# UN/SCETDG/49/INF.4/Add.3 UN/SCEGHS/31/INF.3/Add.3

**Issues relating to the Globally Harmonized System  
of Classification and Labelling of Chemicals: Use  
of the Manual of Tests and Criteria in the context  
of the GHS**

## **Revision of the Manual of Tests and Criteria: Part II: (Chapters 20 to 28)**

**Transmitted by the Chairman of the Working Group on Explosives on  
behalf of the Working Group**

Figure 20.1 (a): FLOW CHART SCHEME FOR SELF-REACTIVE SUBSTANCES AND ORGANIC PEROXIDES

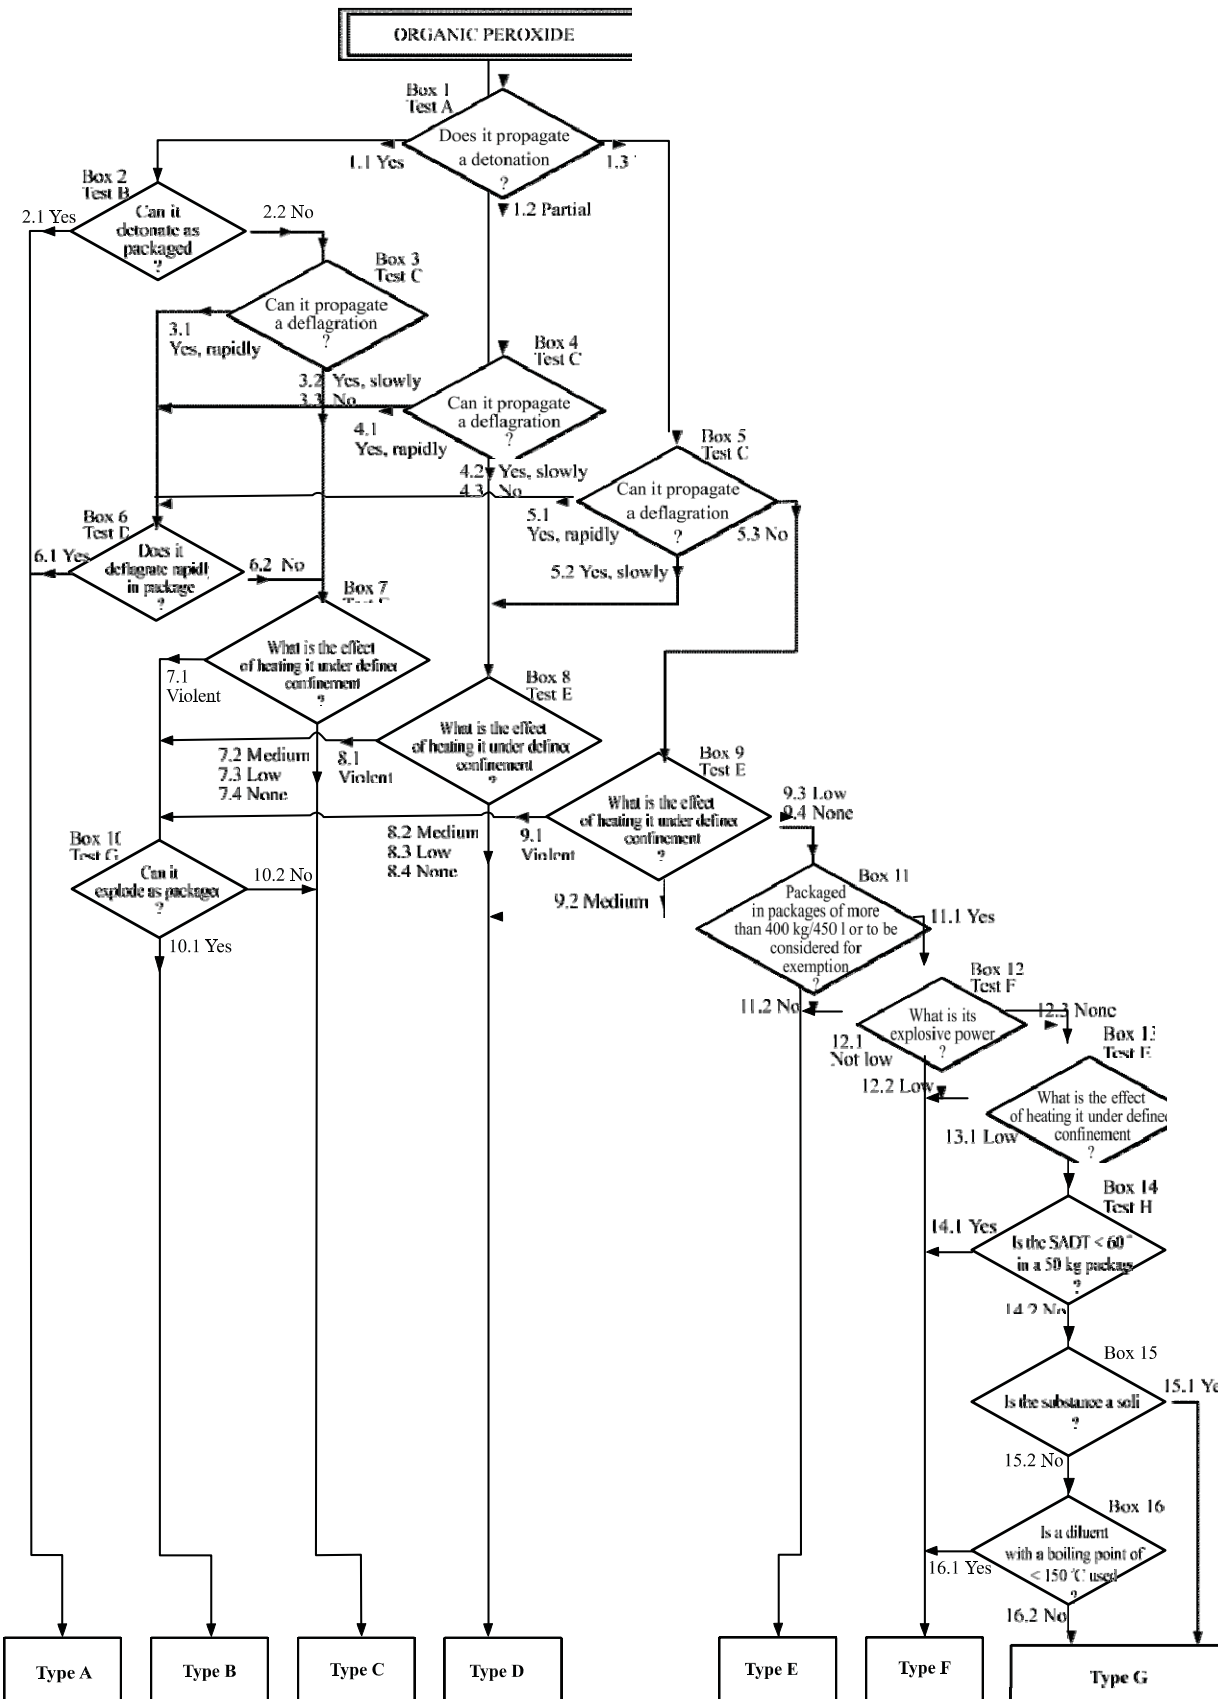
**Figure 20.1 (b):** ~~FLOW CHART SCHEME FOR SELF-REACTIVE SUBSTANCES AND ORGANIC PEROXIDES (cont'd)~~

In box 2 and 10: remove the words “for transport”  
Replace “Exit A” to “Exit D” with “Type A” to “Type D”  
Remove boxes under the “Exits”  
Remove the words “of figure 20.1 (b)” to the reference “go to box 11”
